Access Compliance Report

Public Rights-of-Way

(Curb Ramps)

Intersection ID: N/A	Main Street: PROVIDENCE_RD	Cross Street: N/A	Location: SW
ADA ID: 41A410A26C00	Ramp Type: Perp	Initial Pass/Fail: Fail	Overall Compliance: No
Severity Score: 18.75			
Codes/Mitigation Info/Possible Solution		Field Measurements/Component Compliance

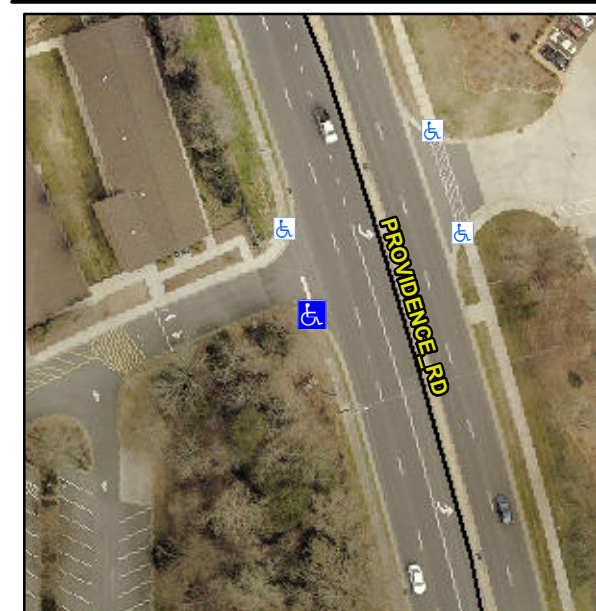
R304.5.1, R304.5.3

Compliance	Description	Data	Compliance	Description	Data
N/A	Ramp Length (in)	85.5	Yes	Ramp Slope (%)	5.5
No	Ramp Width (in)	32.0	No	Ramp XSlope (%)	4.6
N/A	Flare Type LT	N/A	N/A	Flare Type RT	N/A
N/A	Flare Slope LT (%)	N/A	N/A	Flare Slope RT (%)	N/A
N/A	Flare Traversable LT?	N/A	N/A	Flare Traversable RT?	N/A
N/A	Landing Length (in)	N/A	N/A	DWS Provided?	N/A
N/A	Landing Width (in)	N/A	N/A	DWS Contrast?	N/A
N/A	Landing Slope (%)	N/A	N/A	DWS Length (in)	N/A
N/A	Landing X Slope (%)	N/A	N/A	DWS Full Width?	N/A
N/A	Landing Curb? (Y/N)	N/A	N/A	DWS Offset (in)	N/A
N/A	Shared Landing?	N/A			
N/A	Gutter Ponding?	N/A	N/A	Gutter Slope (%)	N/A
N/A	Gutter Lip Ht (in)	N/A	N/A	Gutter X Slope (%)	N/A
N/A	Painted X Walk1?	No	N/A	Painted X Walk2?	N/A
	X Walk 1 Direction	To N		X Walk 2 Direction	N/A
N/A	X Walk 1 Width (in)	N/A	N/A	X Walk 2 Width (in)	N/A
	X Walk 1 Slope (%)	1.7		X Walk 2 Slope (%)	N/A
	X Walk 1 X Slope (%)	8.9		X Walk 2 X Slope (%)	N/A

Remove & Replace Entire Ramp.
